Value Engineering

Final Report

Intake Diversion Dam Fish Protection and Passage Concept Design, Lower Yellowstone Project

July 29, 2002

Concrete Hinged Weir Detail

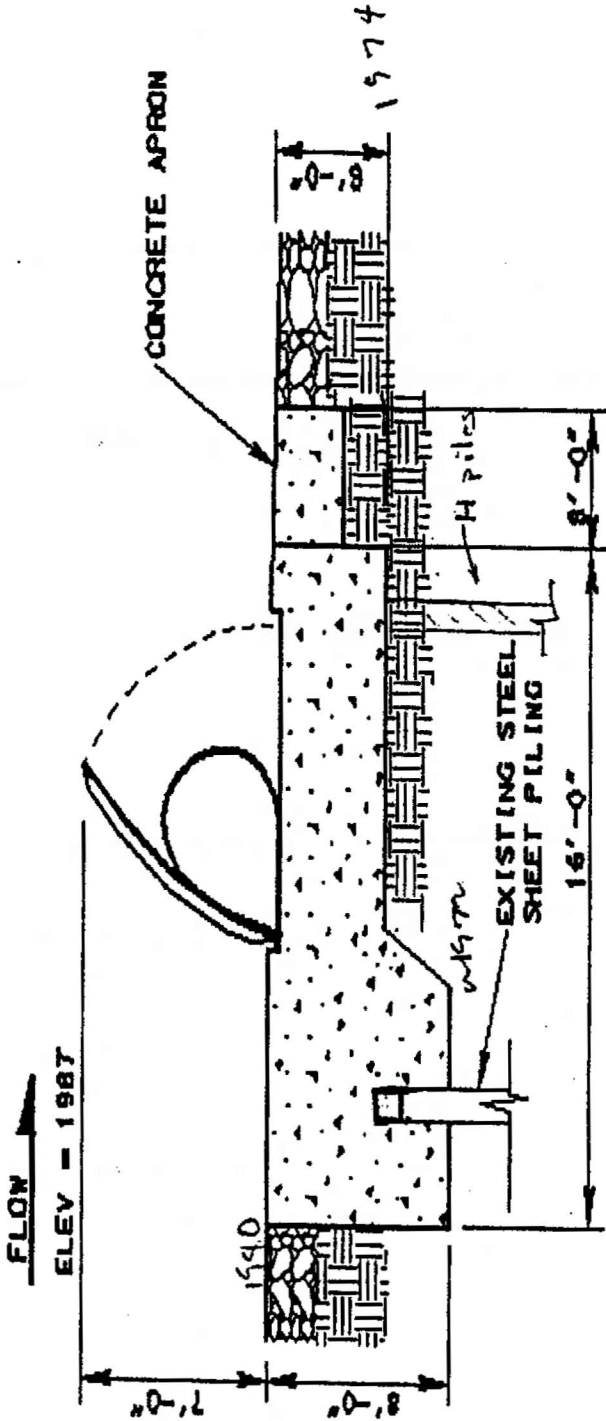
Proposal No. 1. Replace the Dam with a Collapsible Gate System and Fish Passage Channel.

- **Proposal Description:** Because the existing dam has exceeded its design life and requires annual addition of material to the crest to maintain integrity, consider replacing the structure at this opportunity. This proposal would remove the existing dam and replace it with hinged, collapsible gates (Obermeyer style) on a concrete foundation slab. An H piling/bearing should be incorporated to the front and back of foundation slab for added stability. The gates will span about 660 feet across the crest of the dam and will consist of 20 gates that are 33 feet wide. A fish passage channel would be located at or near the south abutment to provide fish passage during low-flow conditions (drought). During high-flow conditions, most or all of the gates could be completely lowered presenting almost no obstruction to movement. As flows begin decreasing in the river, additional gates could be raised, creating sufficient head for diversion of irrigation water. Existing data suggests that the rock that has been deposited on the dam crest through maintenance and has washed downstream has contributed to the impediment of passage of fish such as the pallid sturgeon. Rock that has washed out from the existing structure would be removed and incorporated into the project where applicable.

- **Changes from the Baseline Concept:** Removes and replaces existing dam with hinged weir and fish passage channel. This proposal is likely to increase opportunities of providing fish passage for a wider variety of native fish species over the baseline.

Figure 10. Screen Sill Section

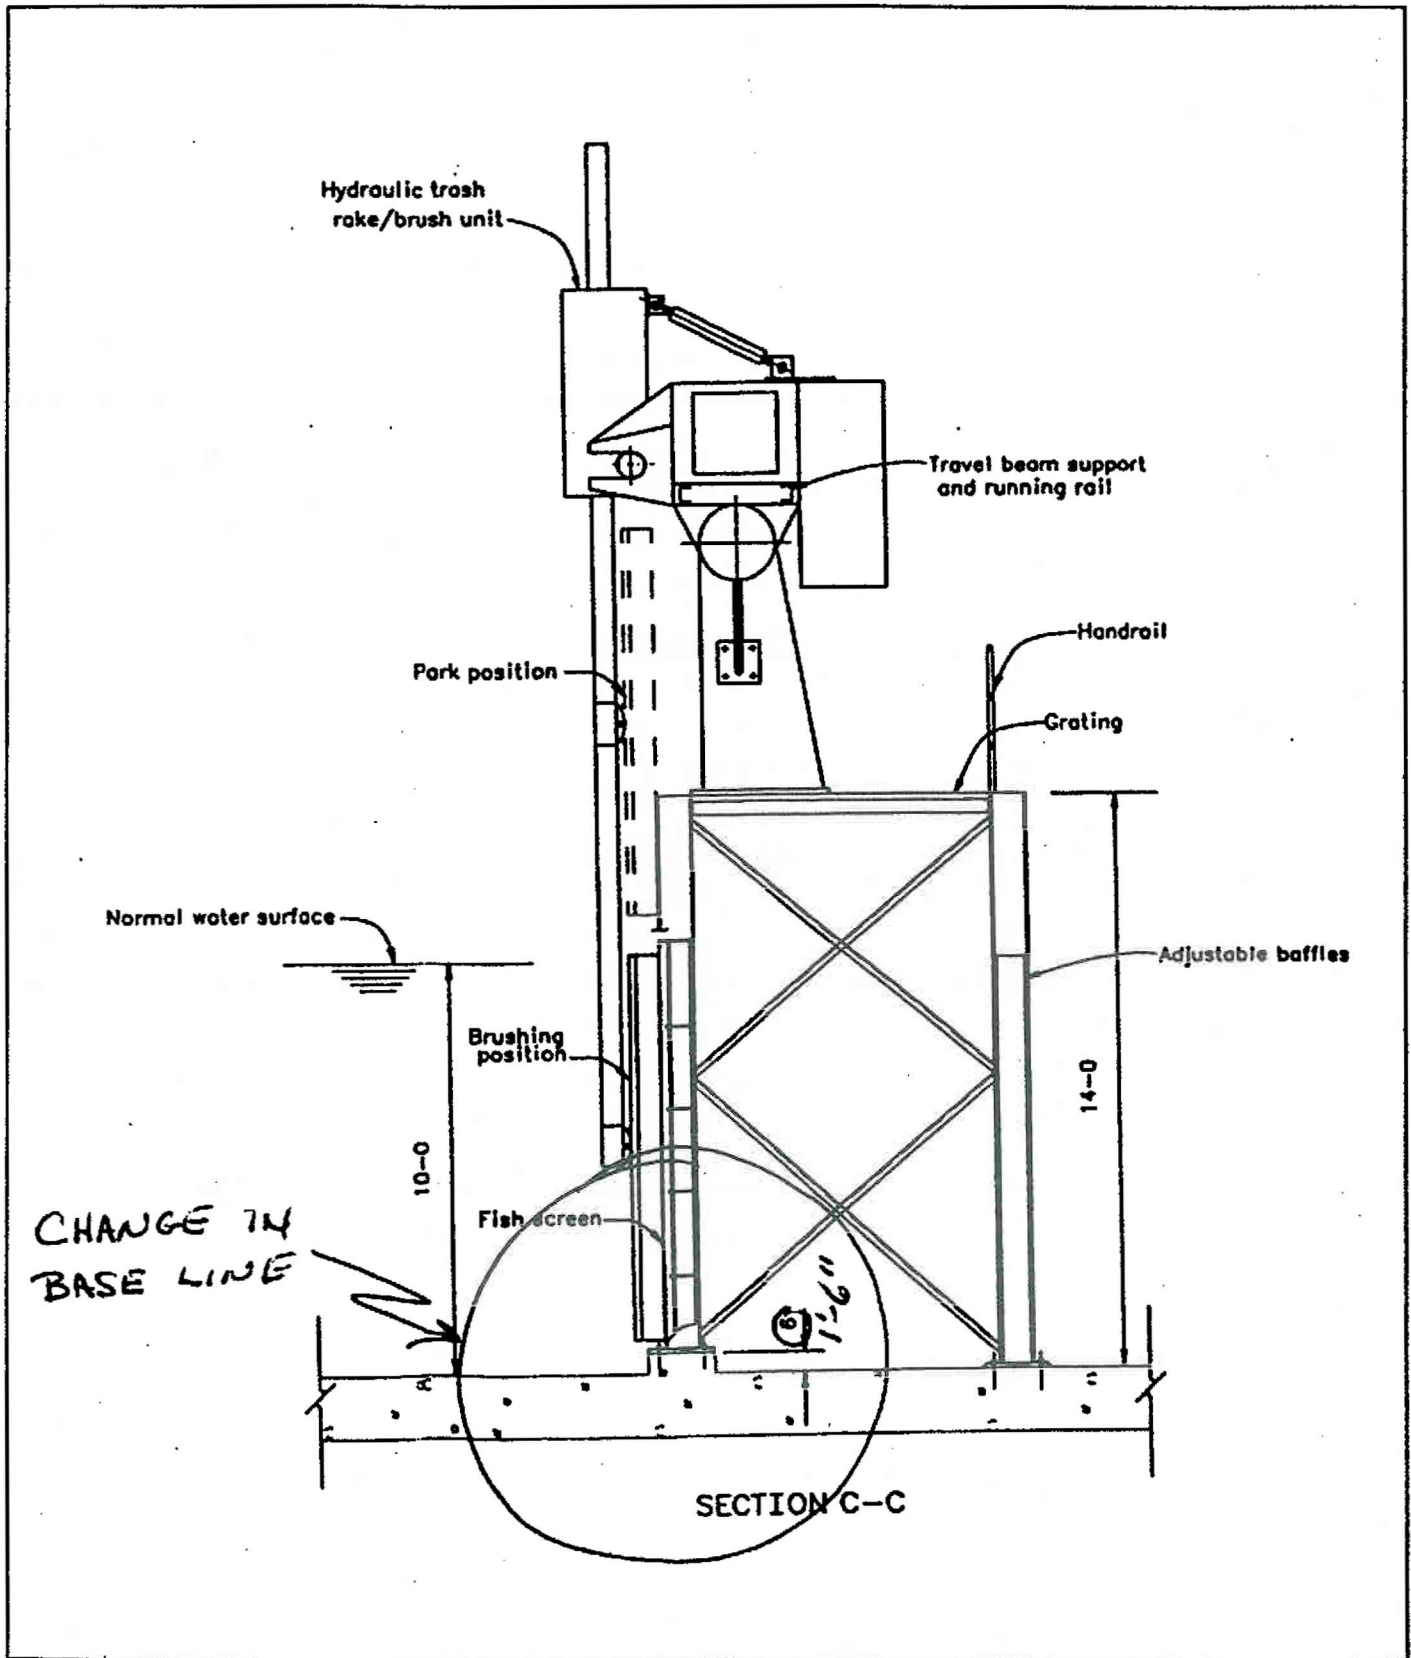
Proposal No. 2. Increase Height of the Concrete Sill under Screens to 18 Inches.

- Proposal Description: This proposal is to change the height of the concrete sill along the base of screen array from 6 inches to 18 inches, primarily to reduce exposure of bottom swimmers to the screens and to prevent silt buildup from impeding the screen cleaning brush. To keep the same wetted screen area, it will be necessary to substitute 37 - 9-foot by 9-foot screens in place of the 30 - 10-foot by 10-foot screens, lengthening the screen array by 33 feet.

- Changes from the Baseline Concept: Total screen length will increase from 300 to 333 feet. As a result, the constant width section length will increase from 350 to 380 feet. The angle of the screen array to the flow will decrease from 9.8 to 8.9 degrees.

Figure 11. Plan of Trap

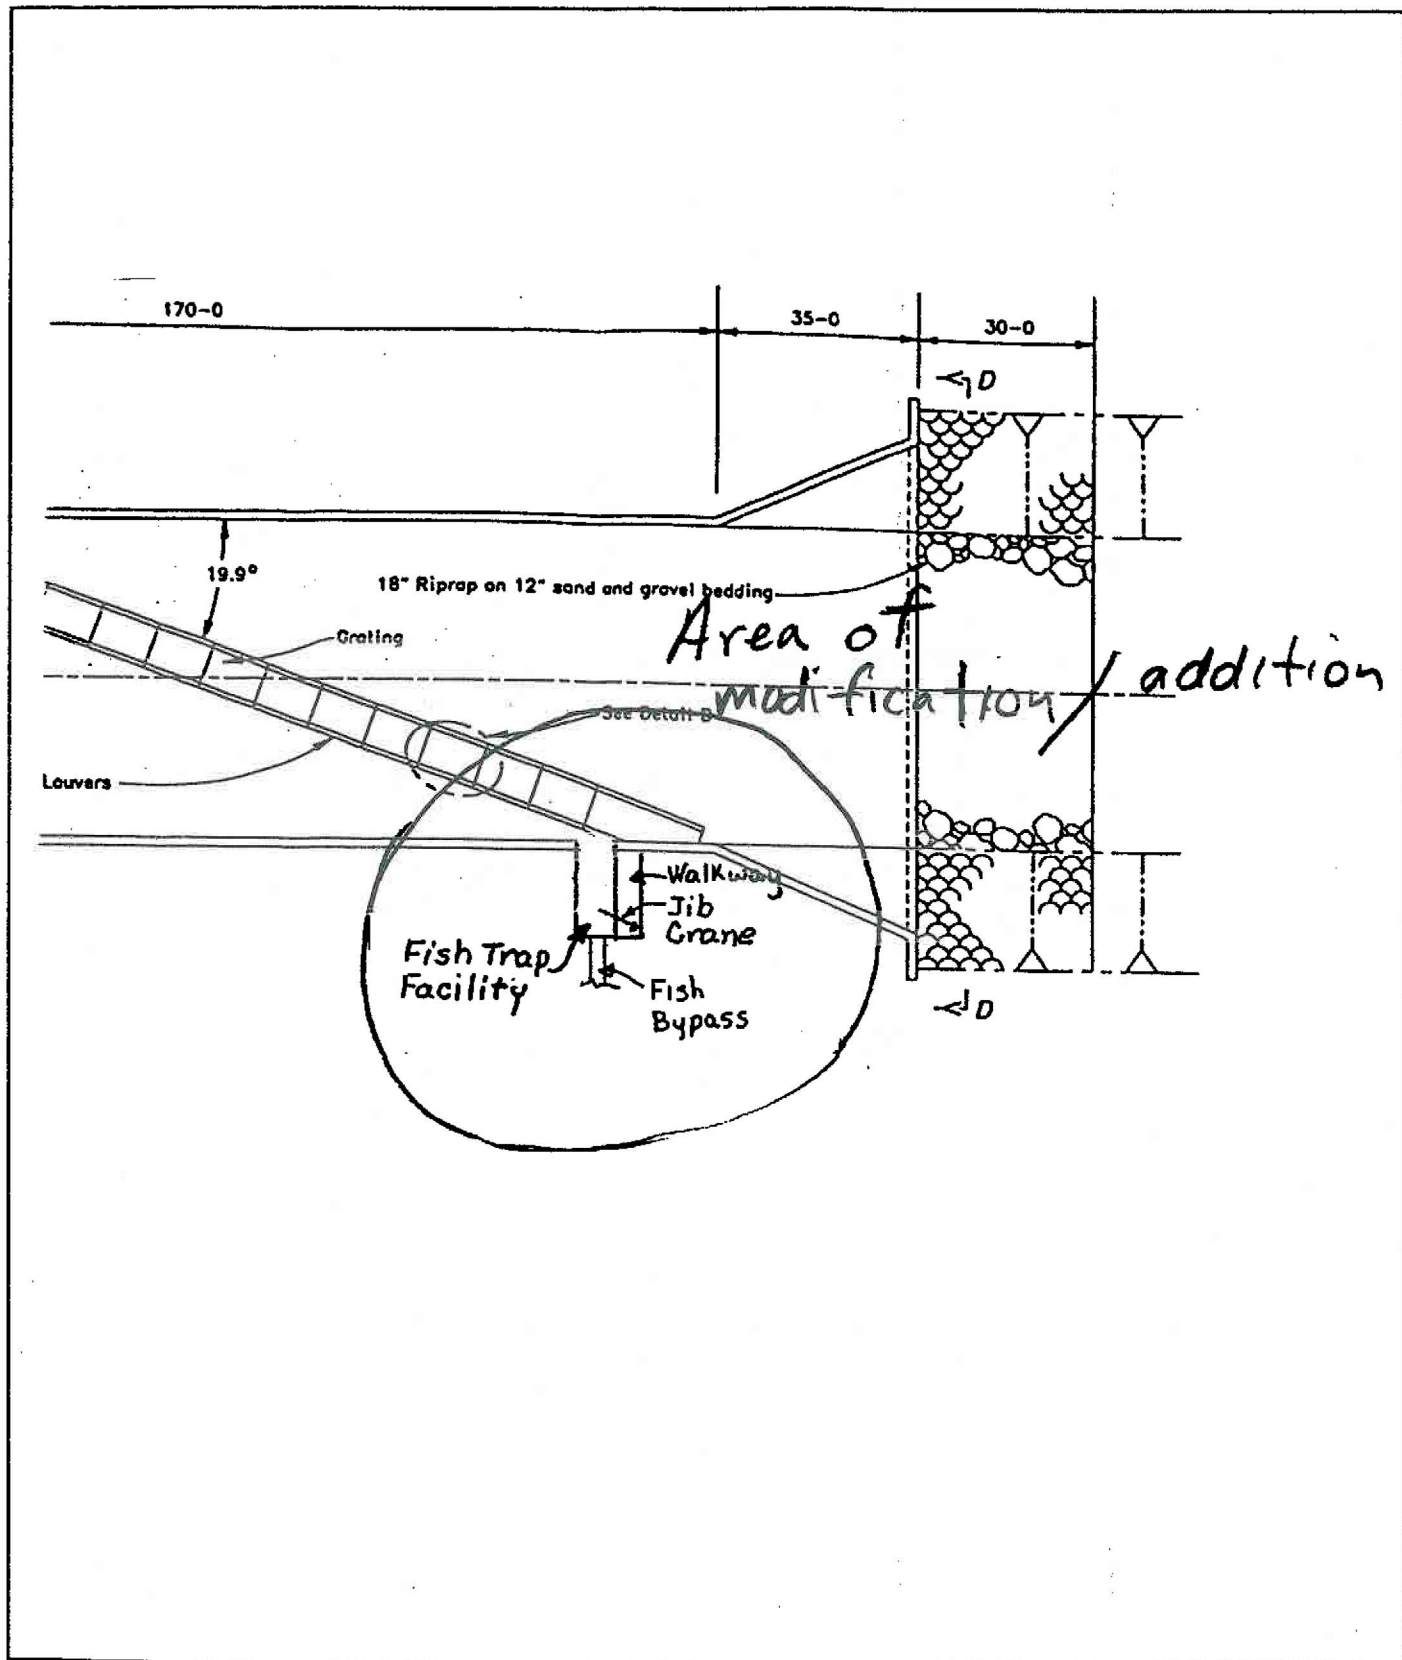
Proposal No. 3. Build a Fish Trapping Facility into the By-pass Area of Intake Canal Screen.

- **Proposal Description:** This proposal is to add a fish collection area and trapping device at the downstream end of the screen array, close to the entrance to the by-pass. The trap would be submerged in the by-passed flow for brief intervals to collect live fish for monitoring and research purposes.

- **Changes from the Baseline Concept:** The baseline does not include a trapping facility. Changes include structural modification at bypass entrance and addition of a hoisting device.

Figure 14. Fish Walkway in Front of Screen

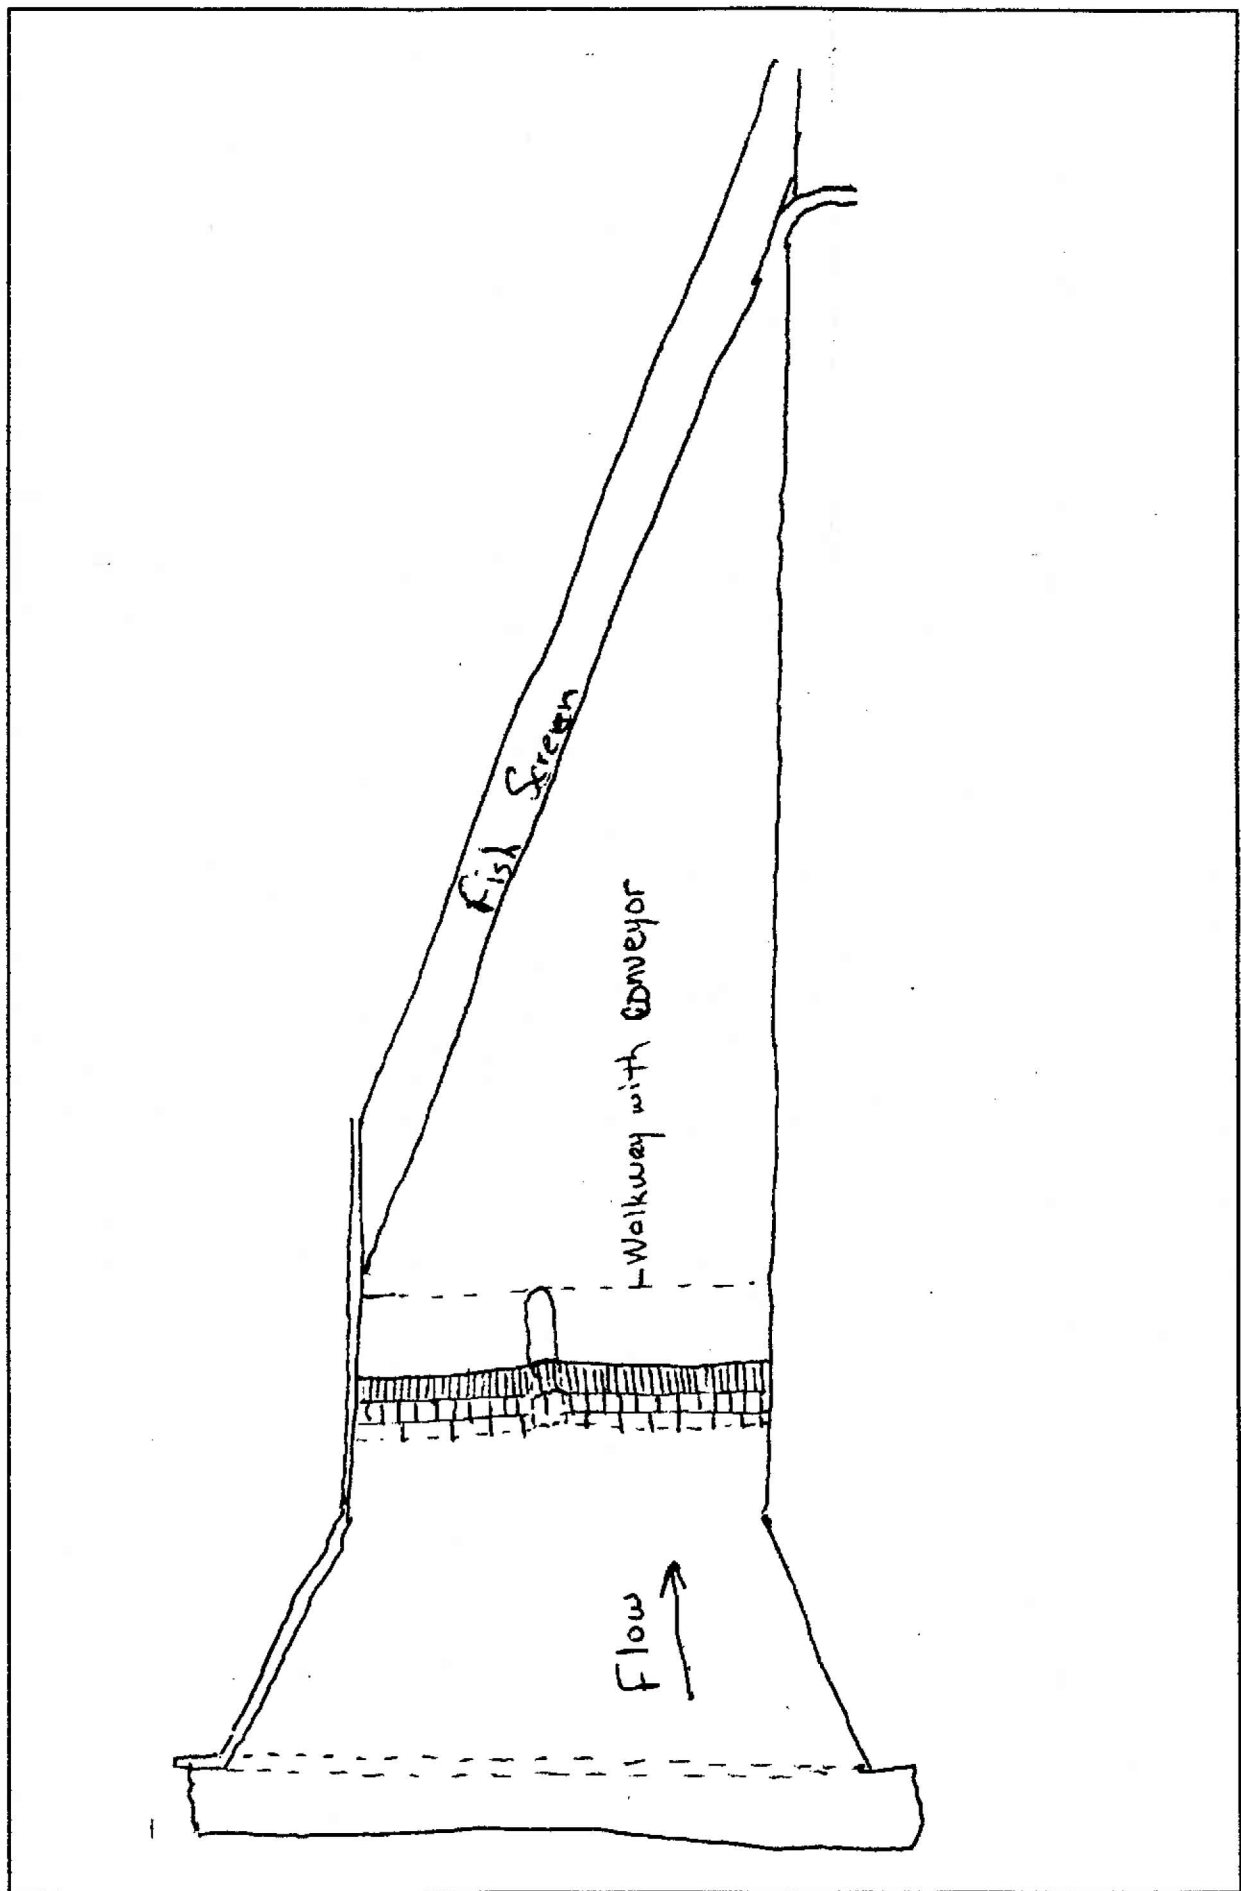
Proposal No. 4. Install Trashrack in Front of the Fish Screen.

- Proposal Description: This proposal would install a trashrack upstream of the fish screen to collect and remove large debris that is entrained through the primary intake. The rack would consist of a structure with a middle pier with variable bar spacing to provide the greatest opportunity for fish passage. The portion of the rack in the upper half of the water profile would consist of bars set vertically with a 4-inch spacing, the mid-section of the water profile would have a spacing of about twelve inches and the lower 3-foot portion would have a spacing of approximately 24 to 48 inches. A hydraulic trash rake and conveyor would be included to provide a mechanical means of removing the debris for collection and removal.

- Ways to Implement: None identified.
- Changes from the Baseline Concept: This proposal would be the addition of a trashrack to increase the effectiveness of the fish screen to function by removing the larger debris.
